**1010 CLERMONT**

**SP-2019-0328C**

# VARIANCE REQUEST

1. To exceed allowable impervious cover of 40% in the Festival Beach Waterfront Overlay without having met specified criteria for allowing 70% maximum allowable impervious cover (LDC 25-2-735(D)).

# Exhibit Showing the Peculiar Shape

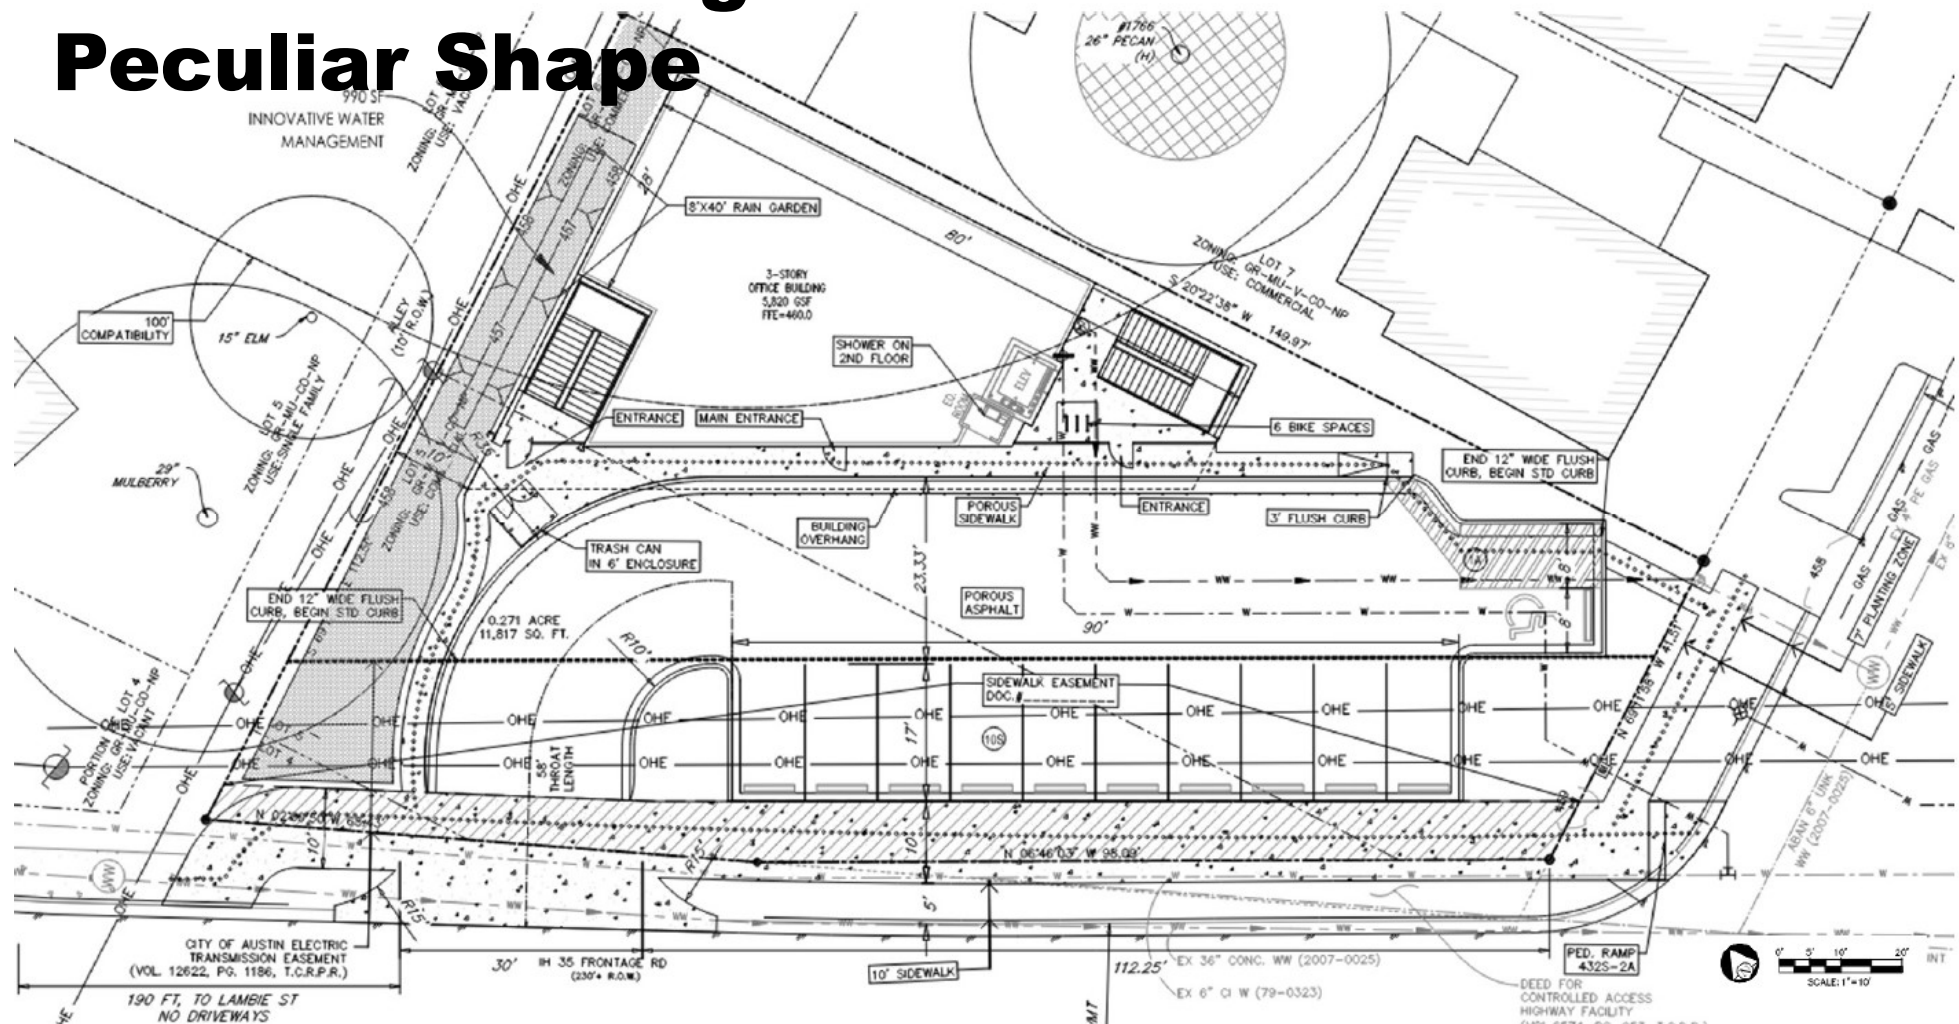
The site is a former used car sales lot. This project proposes an administrative and office building use and has a zoning district designation of Community Commercial (GR) which would normally enable a development with up to 90% impervious cover within the City's zoning jurisdiction that falls within the Urban watershed regulation area. However, this project happens to also be located within the Festival Beach Waterfront Overlay – outside of the primary and secondary set back areas (See slide #11) – requiring it to be limited to 40% impervious cover, unless it can meet certain criteria such as containing congregate care and retail uses on 15 acres or more. Since these requirements are not feasible for this site and since the site is so small (.26 acres) achieving the 40% maximum allowable impervious cover isn't feasible either and would deprive the applicant of a privilege available to owners of similarly situated property. Furthermore, there are other factors constraining the developability of the site such as compatibility height restrictions, a transmission line that runs the entire west side of the site and the peculiar shape of the lot (See slide #12).
